Our Ref: 0394A

Your Ref: SSD - 93020230

**OBJECTION TO SSD 93020230 40-48 REDAN STREET, MOSMAN
PROPOSED DEMOLITION WORKS AND CONSTRUCTION OF A PART 10-STOREY AND
PART 5-STOREY PROPOSED RESIDENTIAL FLAT BUILDING CONTAINING 53
RESIDENTIAL DWELLINGS (INCLUDING 11 AFFORDABLE HOUSING UNITS) WITH 2
LEVELS OF BASEMENT PARKING CONTAINING 106 RESIDENT PARKING SPACES
APPLICANT: MOSMAN LAND NO. 1 PTY LTD**

Figure 6 Base Extract from JMT Consulting TIA with Walking Route to Mosman Town Centre – Incorrectly Calculated

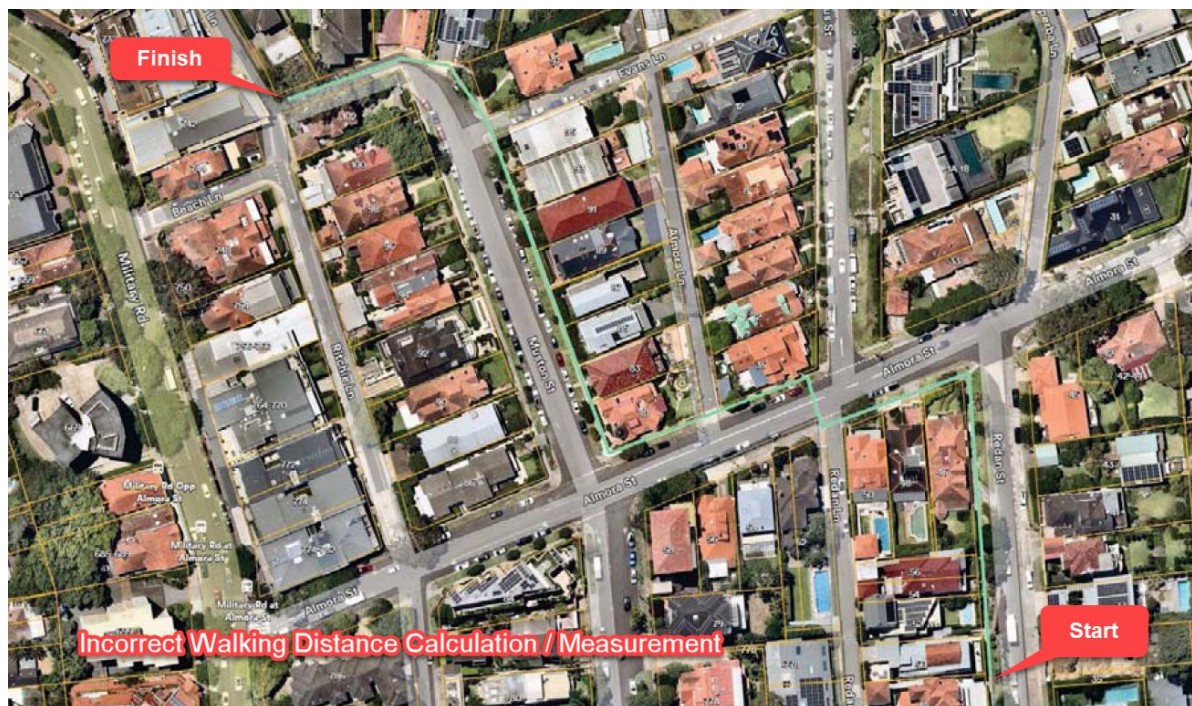
The Applicant's Traffic Impact Assessment (**TIA**) prepared by JMT Consulting outlines the 'Walking route to Mosman Town Centre' (Figure 13/Page 16) which shows the route relied upon marked in green (**Figure 6**):

JMT Consulting describes the route in the TIA and states '*As advised by LTS Surveyors this walking route has a total distance of 394.7m to the nearest 0.1m.*' Although the walking route assessment in the TIA does not rely upon Redan Lane, the measurement of 394.7m is incorrect as the correct measurement of the green line in Figure 13 of the TIA is 404m (**Figure 7**).

Figure 7 Correct Measurement of Green Line in Figure 13 of TIA relied upon by the EIS

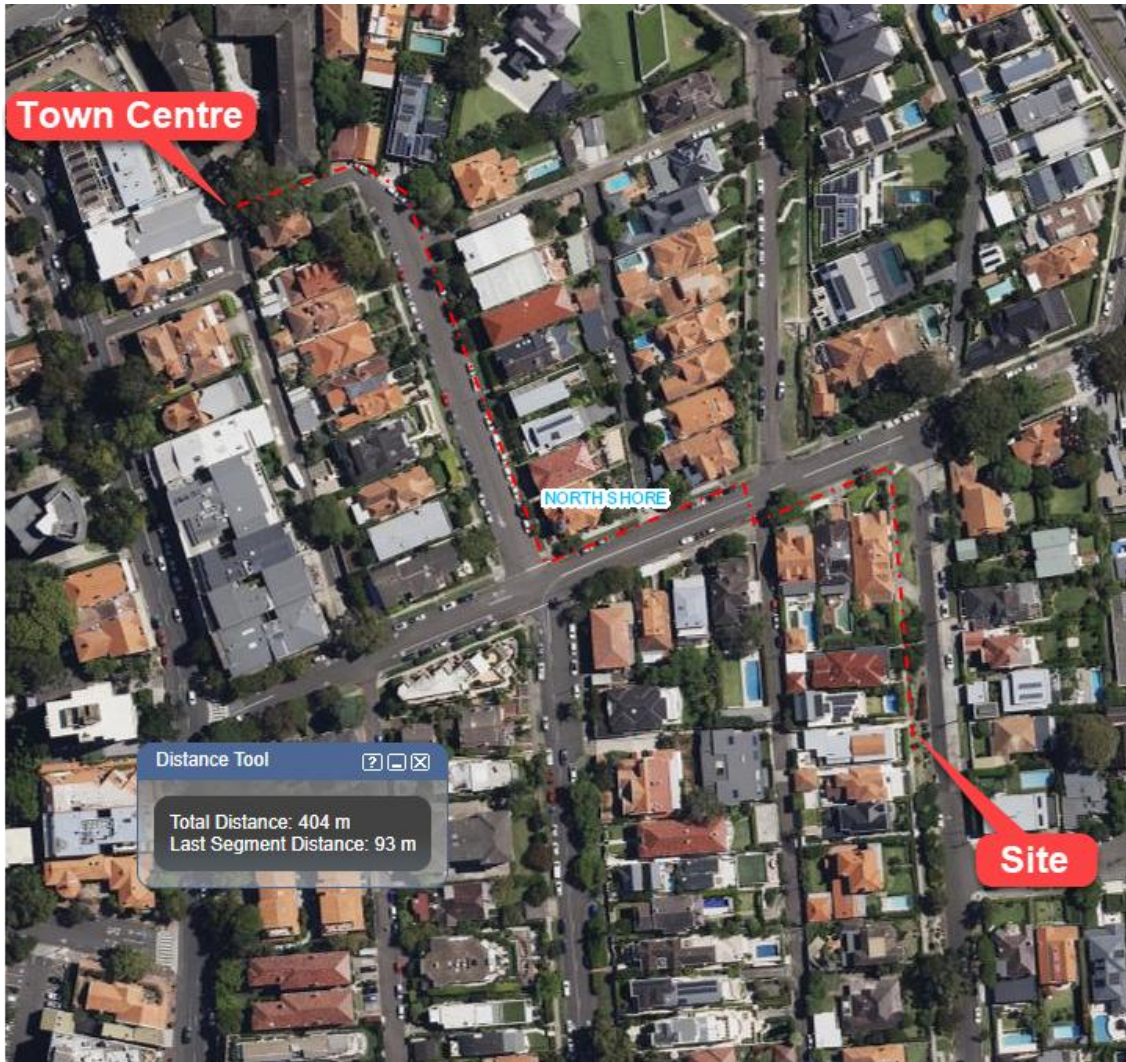
The LTS Surveyors walking route is not provided with the EIS, but in any event, an actual walk of the green line route adopted by the application reveals that this route is neither conducive to being safely walked (including stairs and other obstacles such as parked cars), nor compliant with the definition of 'walking distance in schedule 10 of the Housing SEPP.

Although the TIA does not purport to rely upon Redan Lane as part of any walking route, the EIS nevertheless appears to rely upon an incorrect measurement of 394.7 metres, which has been used to falsely characterise the site as falling within a 'low and mid rise housing inner area' (as defined).

Figure 9 Spit Junction Town Centres map – Extract with SPS Mark-up in Red

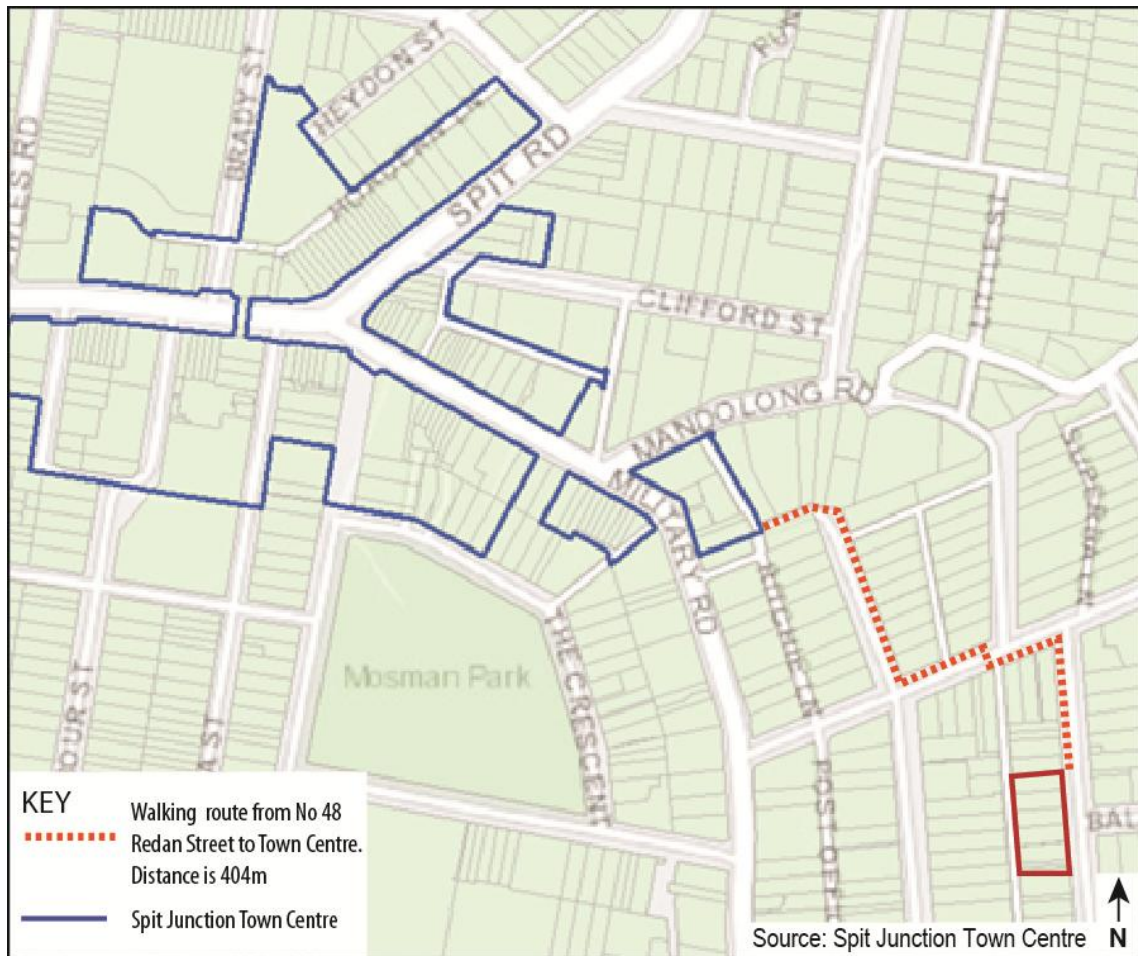
Whilst the site is within a low and mid rise housing area, it exceeds 400m 'walking distance' of the Spit Junction Town Centre and therefore is appropriately categorised as a low and mid rise housing outer area.

Even without using the available pedestrian crossing and by disregarding slope, the site is measured well in excess of 400m from the edge of the nominated Spit Junction Town Centre via the footpaths that can be safely walked by a pedestrian to the Redan Street frontage.

If the route above is amended to include use of the pedestrian crossing and the slope of the footpaths is also factored in to the calculation, the distance measured increases considerably. Given that Section 163 of the Housing SEPP is directed to “walking distance”, there is at least scope to argue that the measurement should not be taken from the closest part of the site to the closest part of a Spit Junction Town Centre, but from the pedestrian entry and exit location of the proposed development on the site to the entry point of the Spit Junction Town Centre itself (as distinct from the boundary of the Spit Junction Town Centre).

Figure 10 – The Mosman LEP 'Scenic Protection Area' bisects the site. (Source: MLEP 2012)

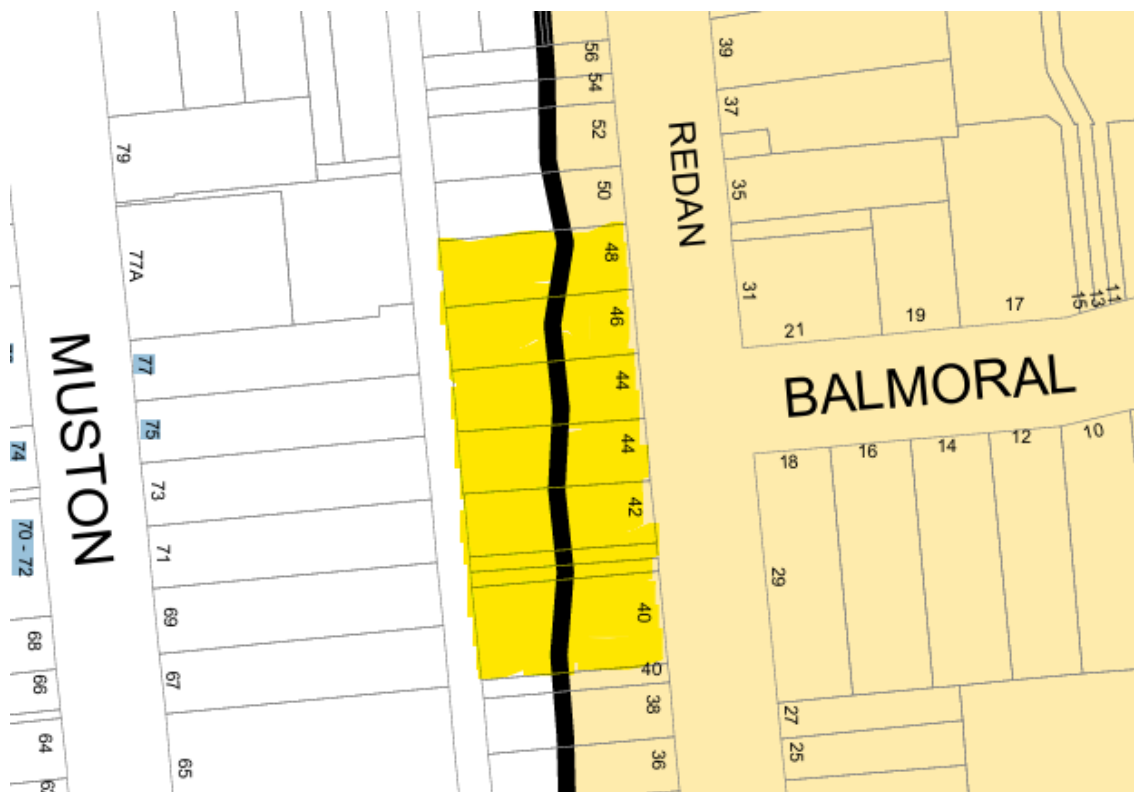
In addition to the site being at the interface between the two zones with the need to be considered as a transitional site, the eastern part of the site is also within the MLEP Scenic Protection Area (**Figure 10**).

Figure 11 Mark-up of East Elevation from Architectural Plan set – FJC Studio

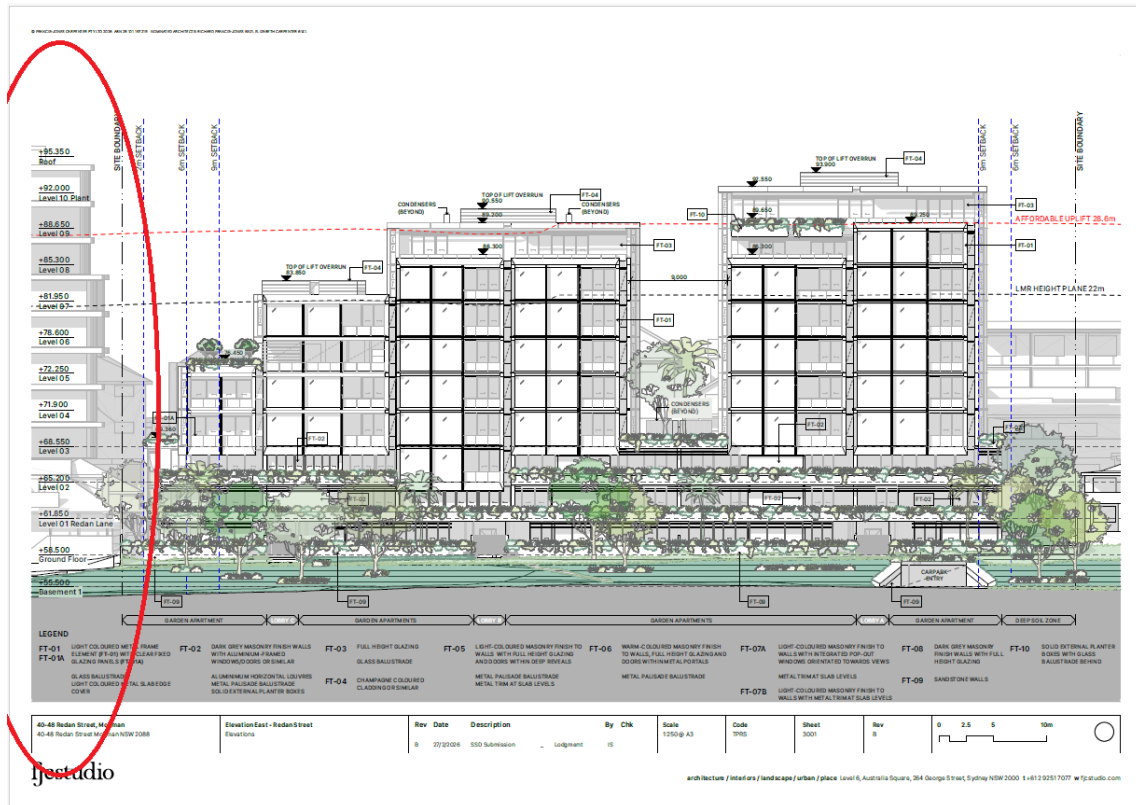
When viewed from the front of the site in Redan Street, the East Elevation drawing in the Architectural Plan set prepared by FJC Studio incorrectly shows a taller building to the left side of the site (i.e. to the south), yet there has been no approval granted for any such building (**Figure 11**).

SPS is aware of another proposal for a considerably lower building (i.e. 4 storeys) as part of DA8.2025.235.1 which was refused on 18 February 2026. **Figure 11** shows buildings of comparable height surrounding the proposal when neither such building exists, nor has been approved.

Information on the Architectural Plan elevations is misleading, as it attempts to incorrectly portray the development as being consistent with the existing character of residential development in this location of Mosman (or with recently-approved development) – which it is not. The architectural plans incorrectly label Redan Lane when it should be Muston Street.

Figure 14 Development site (green) and its relationship to surrounding heritage items (Source MLEP)

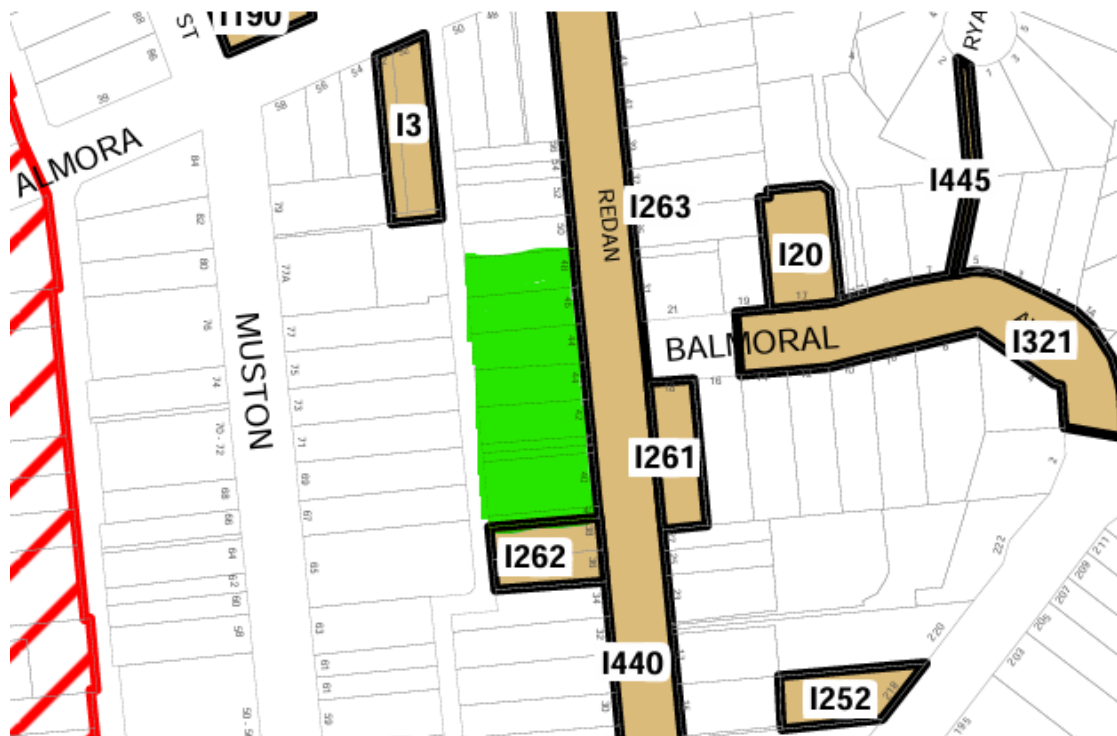
The site has a number heritage items located within the surrounding locality as recognised under Schedule 5 of MLEP, including (Figure 14):

If the proposal is constructed in its current form there will be insufficient distance separation between the heritage items to allow for a part 5-storey part 10 storey building and appropriate transition heights between the sites. The proposal includes a 10-storey residential flat building element that is considerably higher than the existing development on the site and also considerably higher than any other development in this location which consists of buildings up to 2 storeys in height.

Figure 15 Proposed Vehicular Access onto Heritage-listed Road Reserve (Redan Street)

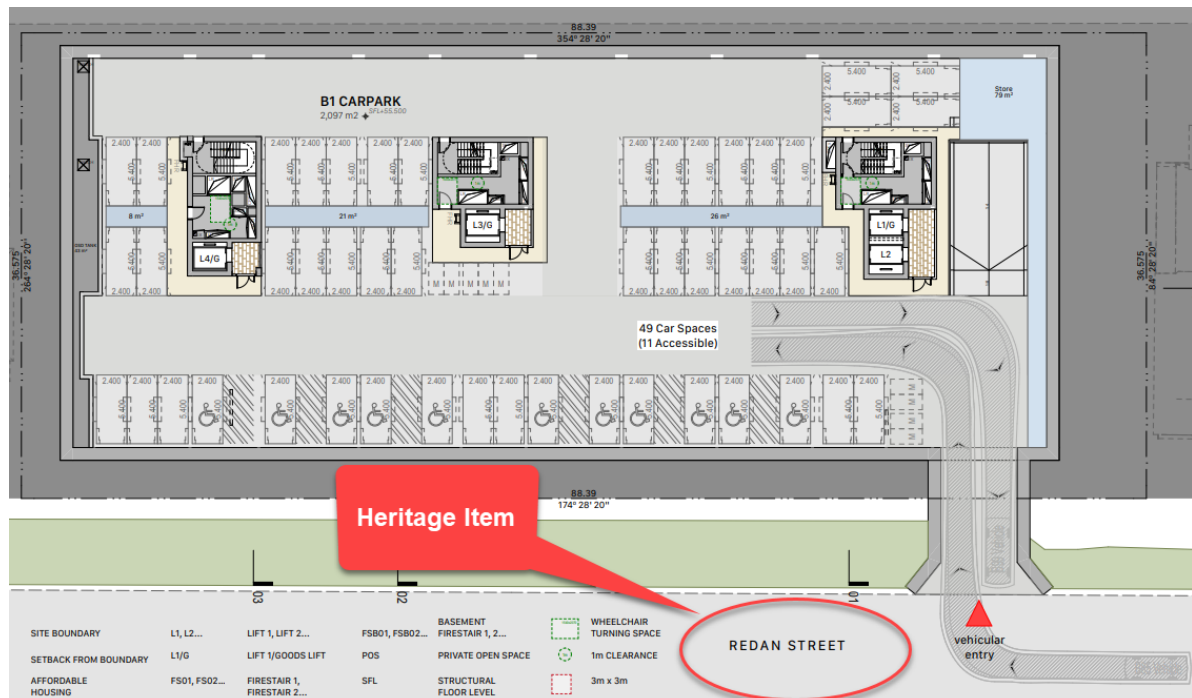
Redan Street has a carriageway that has a significant rock wall and landscaped embankment. The road narrows to the south where the character of the road is more evident with the significant rock wall and pedestrian pathway being at a different level from the carriageway. The proposal to include access to 106 car parking spaces from Redan Street disregards the heritage significance of this road reserve and indicates that the site is unsuitable for the development (**Figure 15**).

Figure 20 Section of the development (Source: Clause 4.6 Variation Request Building Height, prepared by Urbis)

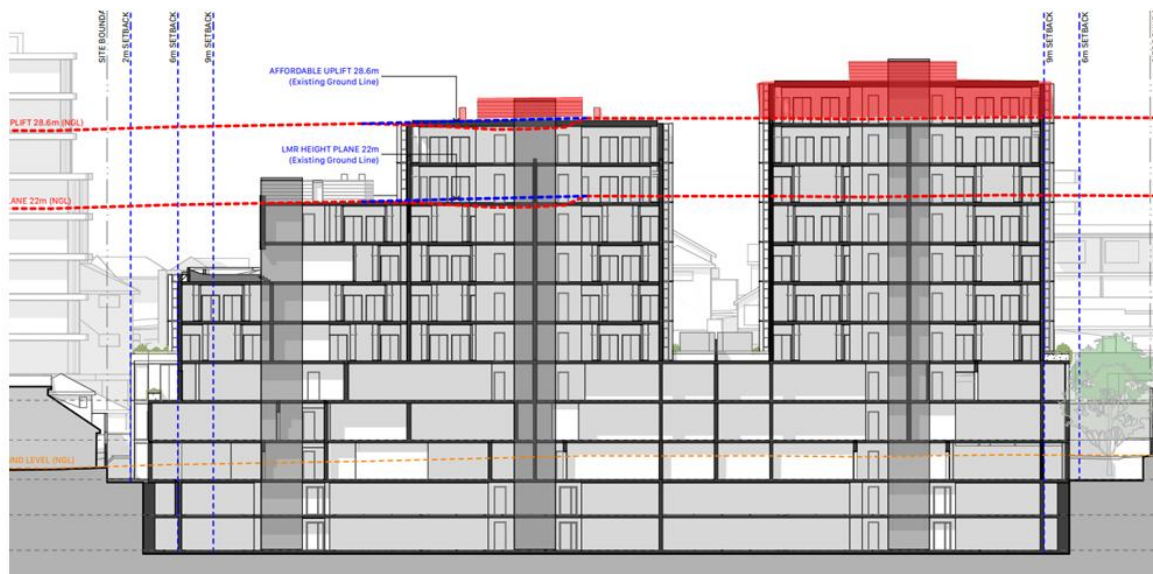
Figure 20 indicates that the proposed development will benefit from an additional storey on the northern tower.

Whether it was the intent of the Housing SEPP to apply to additional storeys as well as FSR/height(m) is irrelevant. What is relevant is that the applicable environmental planning controls are ambiguous and the Applicant appears to have relied upon this in which to support an overbearing development within a scenic protection area that creates an unsatisfactory visual impact and adverse impacts on surrounding development and heritage items together with severe to devastating view loss.
